Service Bulletin

Bulletin No.: 06-03-09-004J

Subject: Squeak Noise from Rear of Vehicle (Lubricate Rear Leaf Springs)

This Bulletin has been revised to add the 2018 Model Year and the Express and Savana models. Please discard Corporate Bulletin Number 06-03-09-004I.

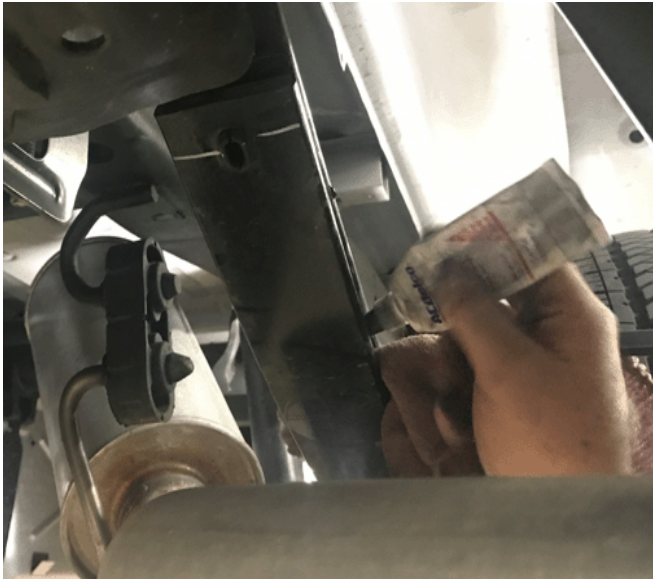
Note: Ensure any tool used to gently pry the tip inserts or spring leaves is protected to prevent damage to the spring leaves.

5. Apply a liberal amount of grease, P/N◆19356408 (in Canada, use P/N◆19356409), both underneath and on top of the front and rear tip inserts for the #2 and #3 leaves, as indicated above. A screwdriver can be used to gently pry up the leaf; however, a rag around the screwdriver must be used to prevent damage to the leaf. Use a flat-bladed tool, such as a gasket scraper or a brush to properly distribute the grease at least 6 inches from each end of the leaf.
6. Lower the vehicle to the ground and test drive to verify the repair.
